INSTRUCTION TO SERVICE

ITS61387		DATE:07/14/2025
SECTION:	526 - SEATS, STANCHIONS, MODESTY PANELS	
SUBJECT:	Rework emergency exit window decals – D45CRT EN/SP 57P W/O LAV	
ISSUE:	Emergency exits labelling are noncompliant to the requirements of FMVSS Standard No. 277, <i>Bus rollover structural integrity</i> .	
SUMMARY:	Addition of corrected/additional decals to bring the coaches back into compliance. Ensure instructional labelling are within the occupant space required by the standard.

Ref. NHTSA Recall No.	Ref. Transport Canada Recall No.
24V457	2025-367

Figure 1: RH Curbside Interior of the Coach

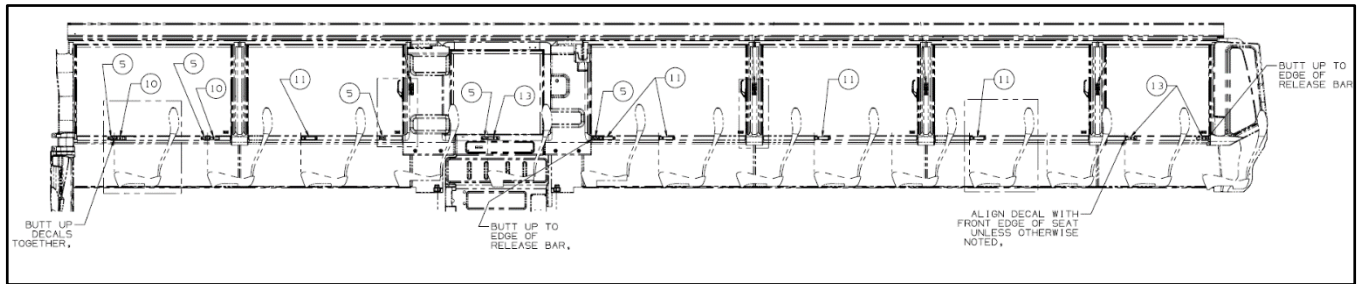
3. On the interior of the coach, locate the new horizontal emergency nameplates.
4. It is important to follow nameplates positioning as shown on Figure 1 and 2 for coach to be safety compliant.

Note: If the decals exist in the below locations, confirm whether the PNs match. If decals don't match, remove by drilling the rivet and install new decals as per below.

Figure 3: Nameplate and Existing Decal

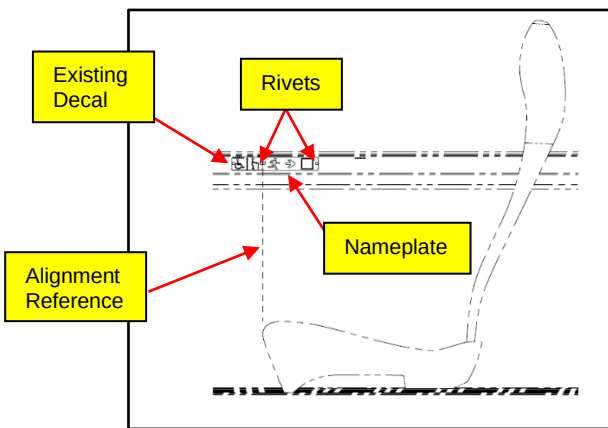
5. As shown on Figure 3, butt up nameplate together with existing decal (NF PN: 03-15-7278 ref).
6. Position nameplates, items 10 to 13, as close as possible to the front edge of the seat cushion (See Figure 4).
If there is not enough room to line up with front edge of seat, butt up to edge of release bar as (See Figure 5 and 6).
7. As required, match-drill a 0.12" dia x 0.37" deep hole using the nameplate being mounted as a template.
Repair/patch up existing unused holes as necessary.
8. Use rivets (NF PN: 19-13-24) to mount new nameplates at the specified locations.
